BARBARICK RECYCLING AND REFUSE TRANSFER STATION

GRADING AND EROSION CONTROL PLAN
DECEMBER 2023

Grading & Erosion Control Plan Comments.pdf Markup Summary

BARBARICK WASTE TRANSFER STATION
EL PASO COUNTY, COLORADO
GRADING AND EROSION CONTROL
INTERIM GEC PLAN

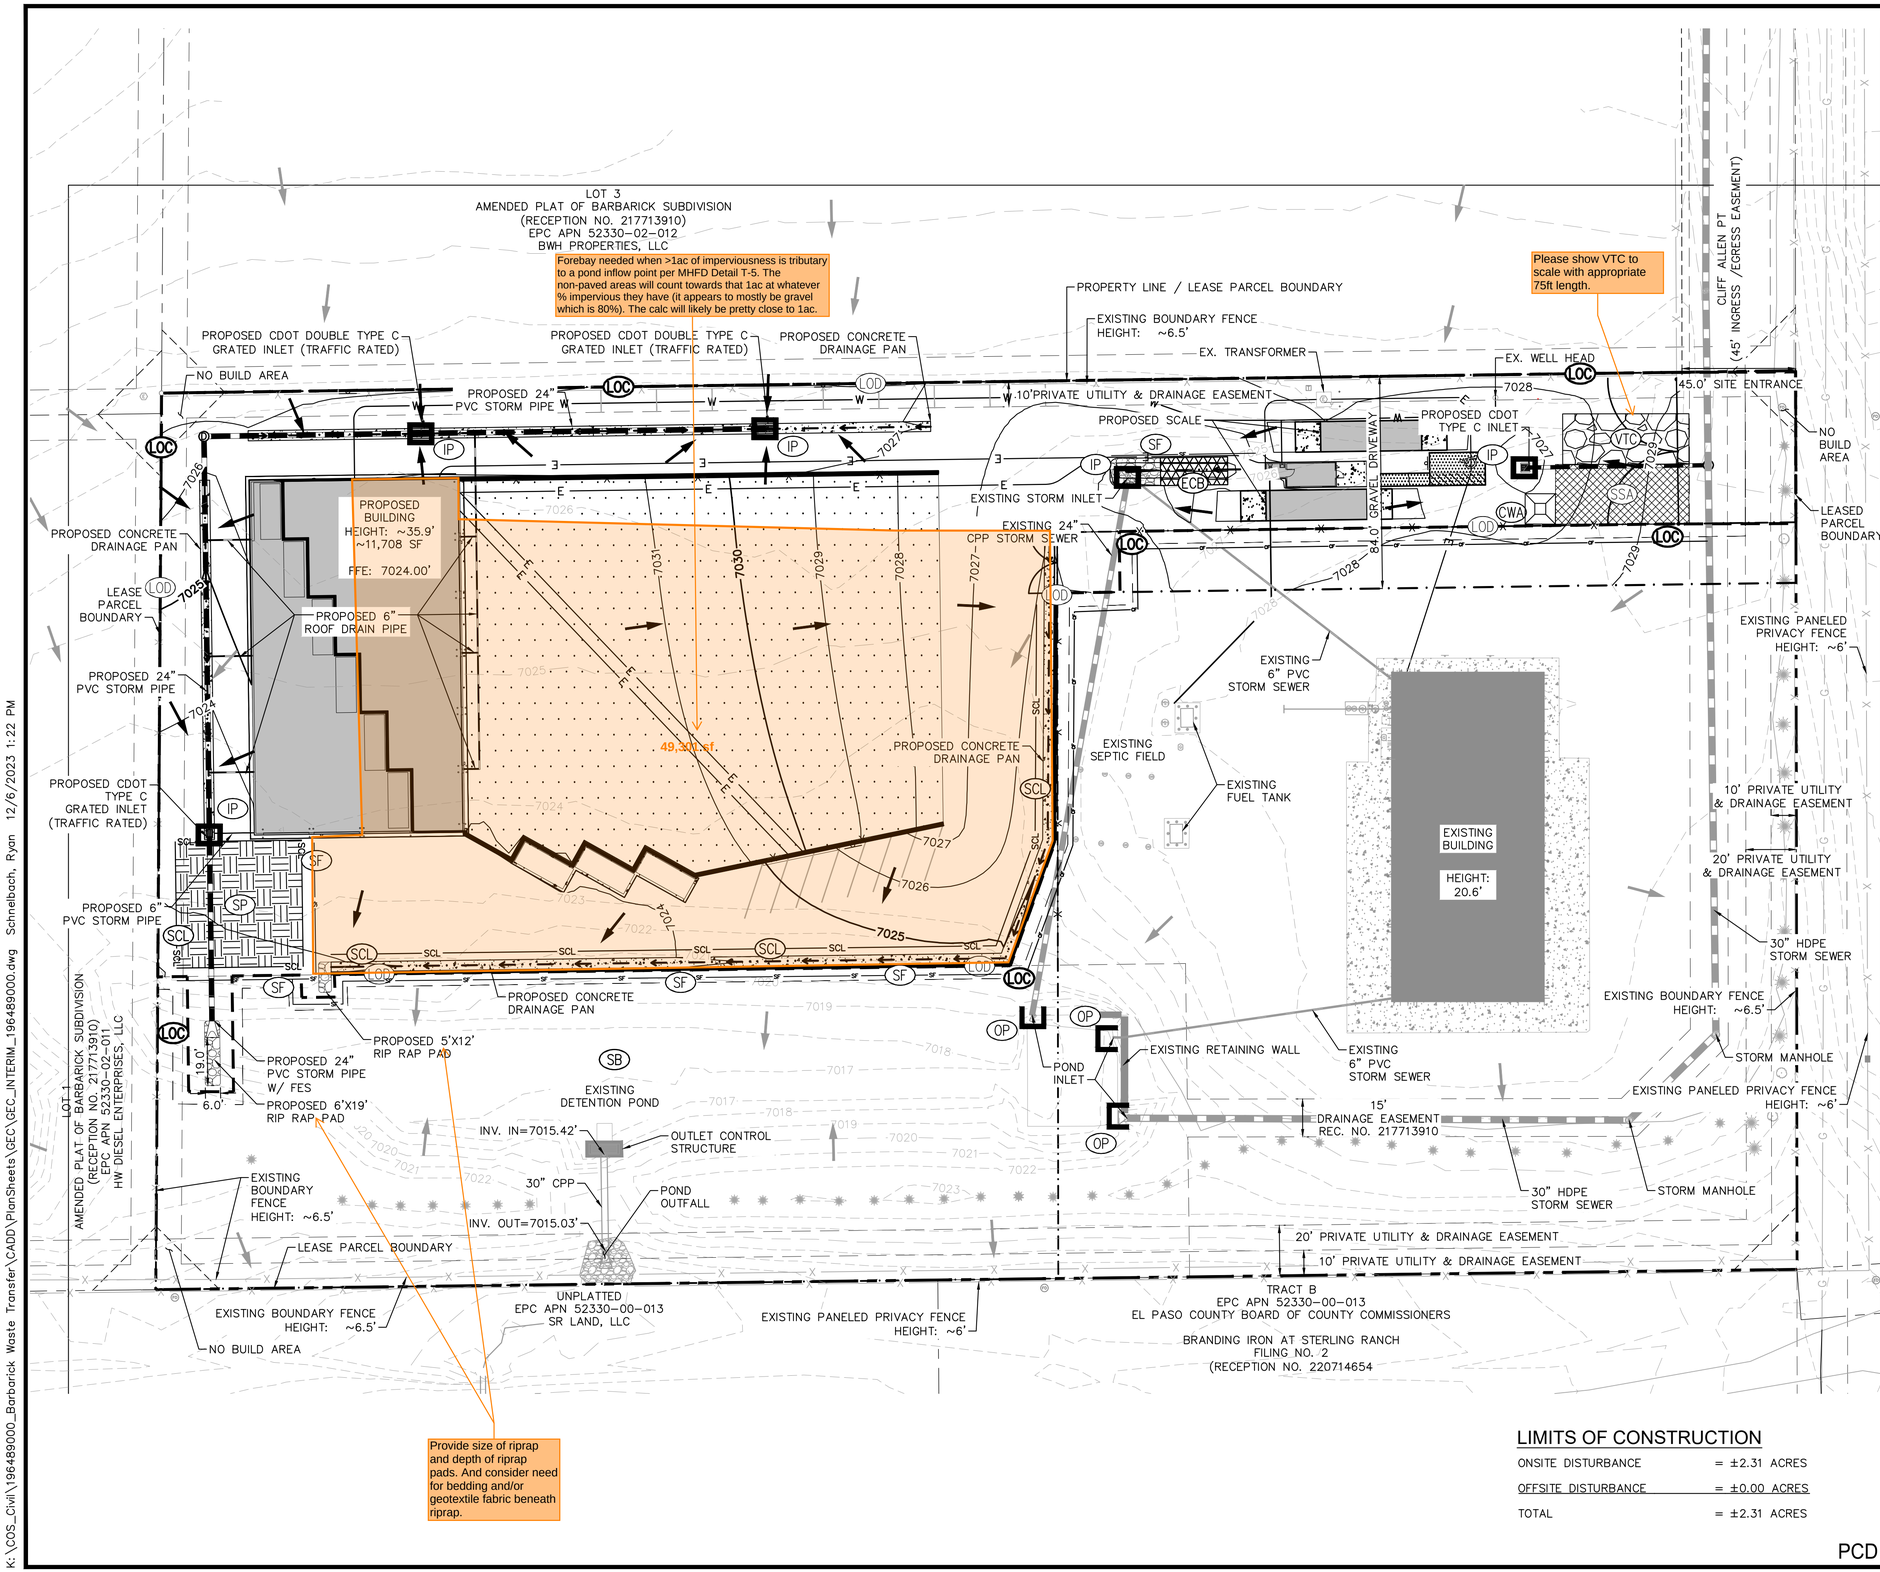
Subject: Area Measurement
Page Label: [5] 5 INTERIM GEC PLAN
Author: Glenn Reese - EPC Stormwater
Date: 1/25/2024 11:06:33 AM
Color:

Forebay needed when >1ac of imperviousness is tributary to a pond inflow point per MHFD Detail T-5. The non-paved areas will count towards that 1ac at whatever % impervious they have (it appears to mostly be gravel which is 80%). The calc will likely be pretty close to 1ac.

Provide size of riprap and depth of riprap pads. And consider need for bedding and/or geotextile fabric beneath riprap.

Please show VTC to scale with appropriate 75ft length.

BARBARICK WASTE TRANSFER STATION
EL PASO COUNTY, COLORADO
GRADING AND EROSION CONTROL
FINAL GEC PLAN

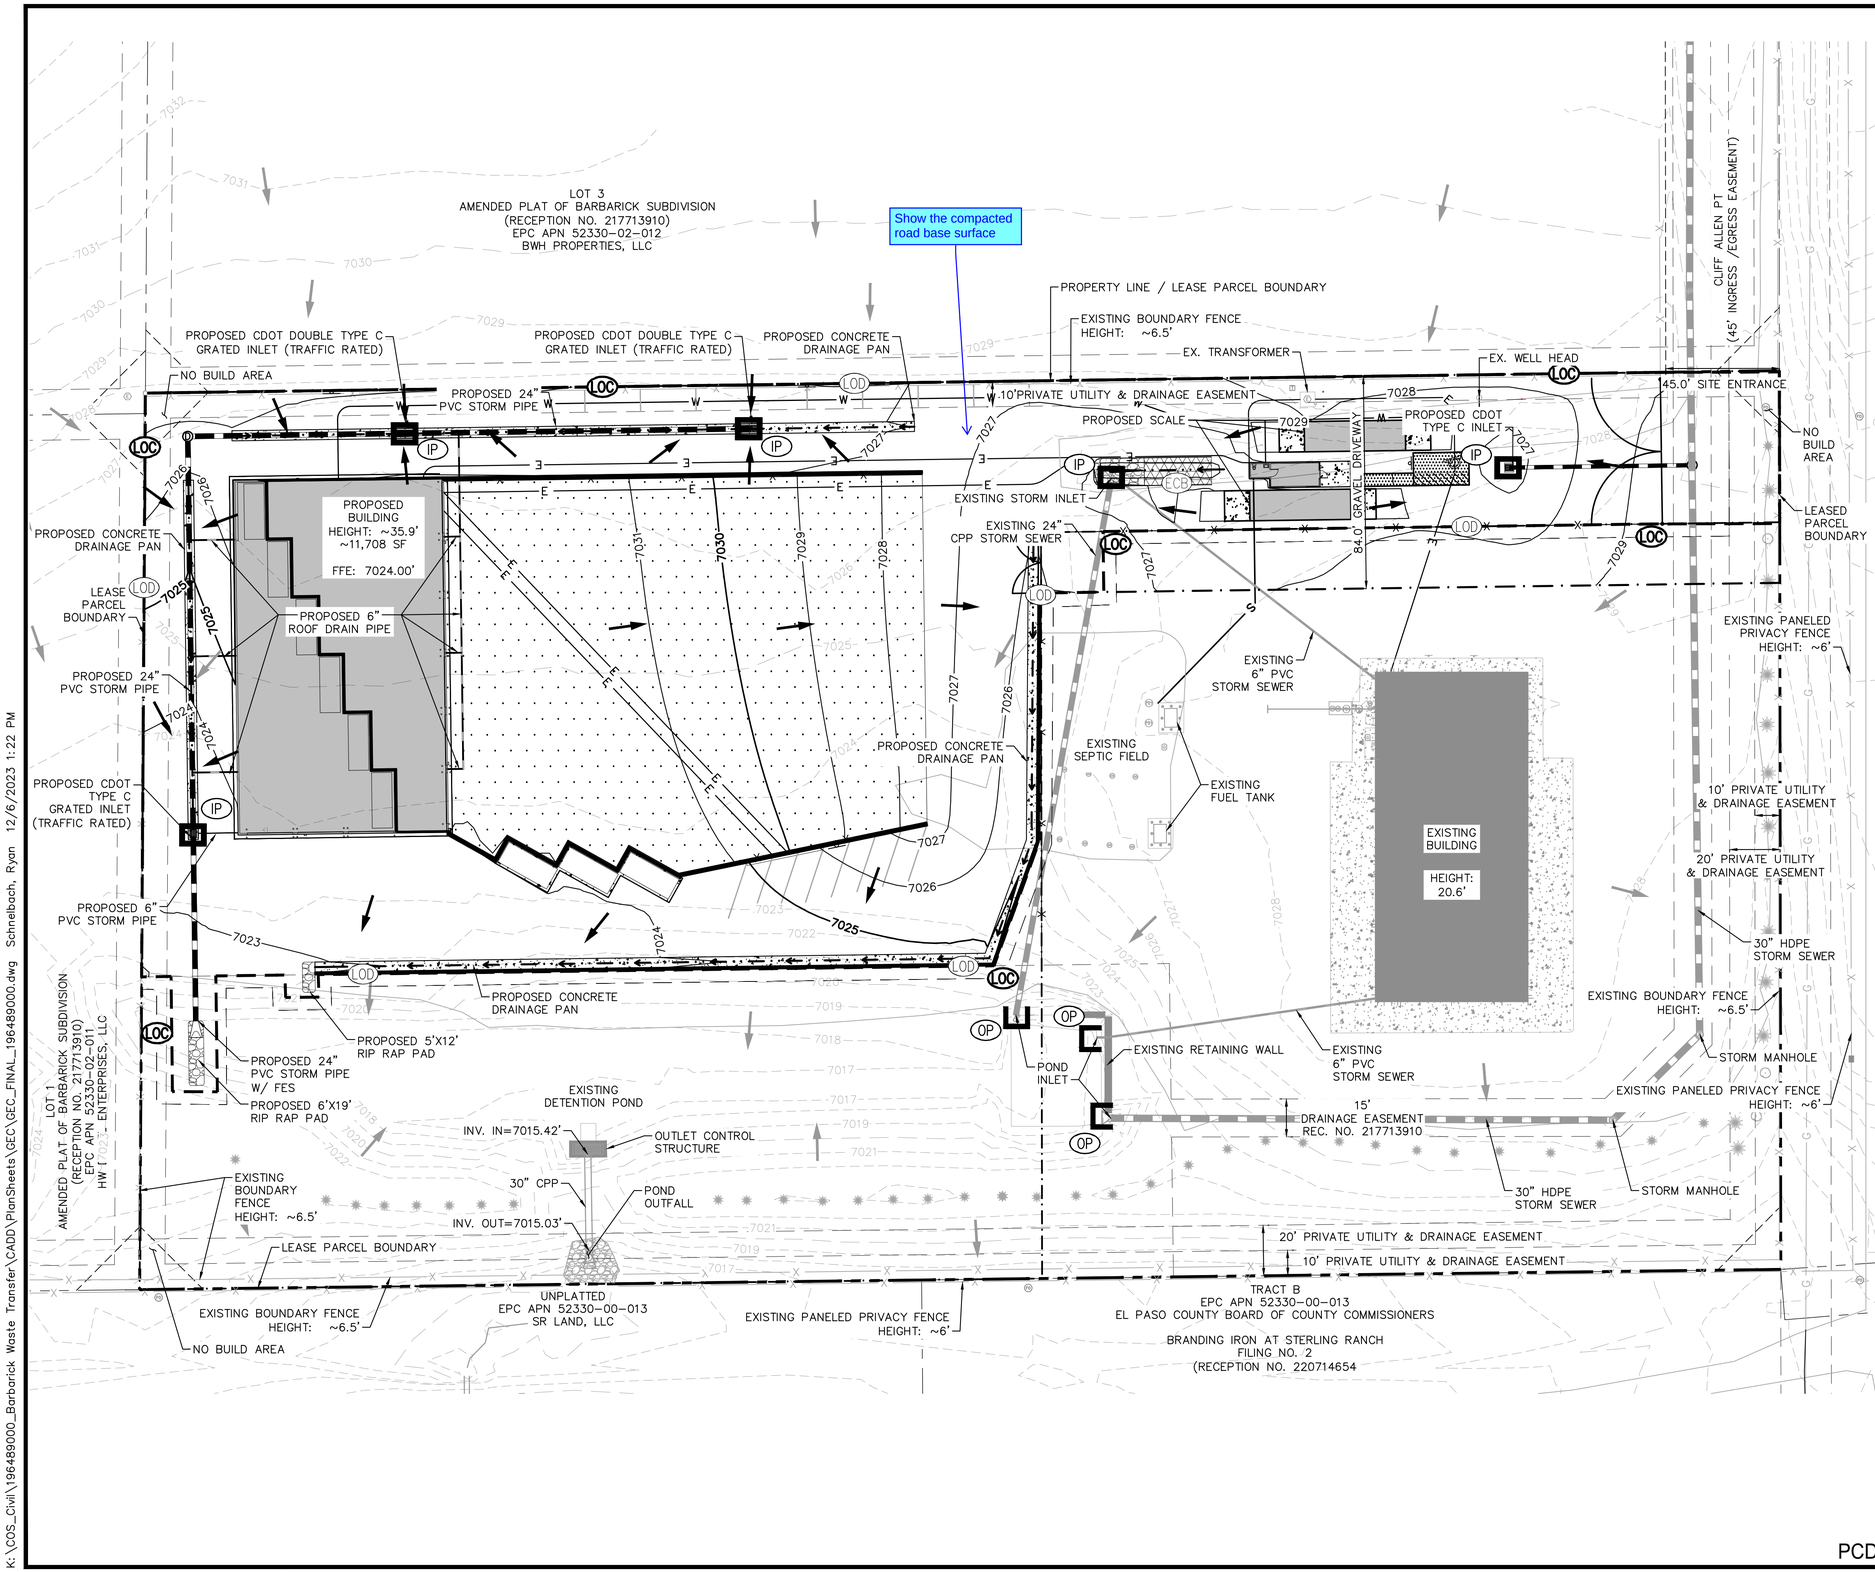
Show the compacted road base surface

VTC-1. AGGREGATE VEHICLE TRACKING CONTROL

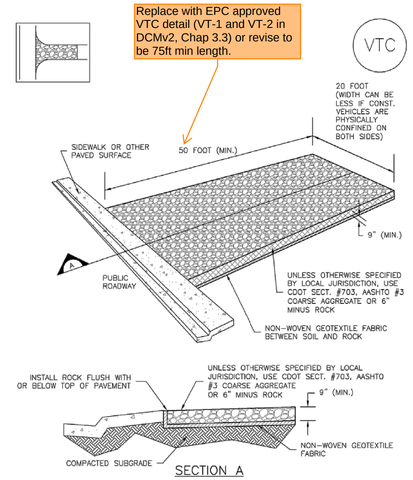
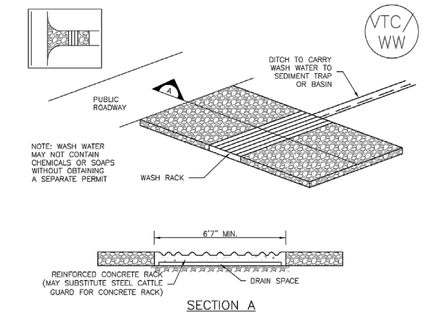
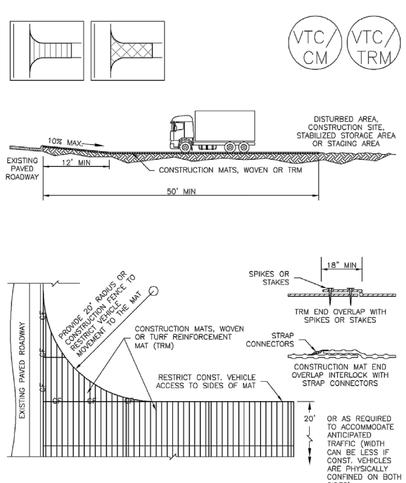
Replace with EPC approved VTC detail (VT-1 and VT-2 in DCMv2, Chap 3.3) or revise to be 75ft min length.
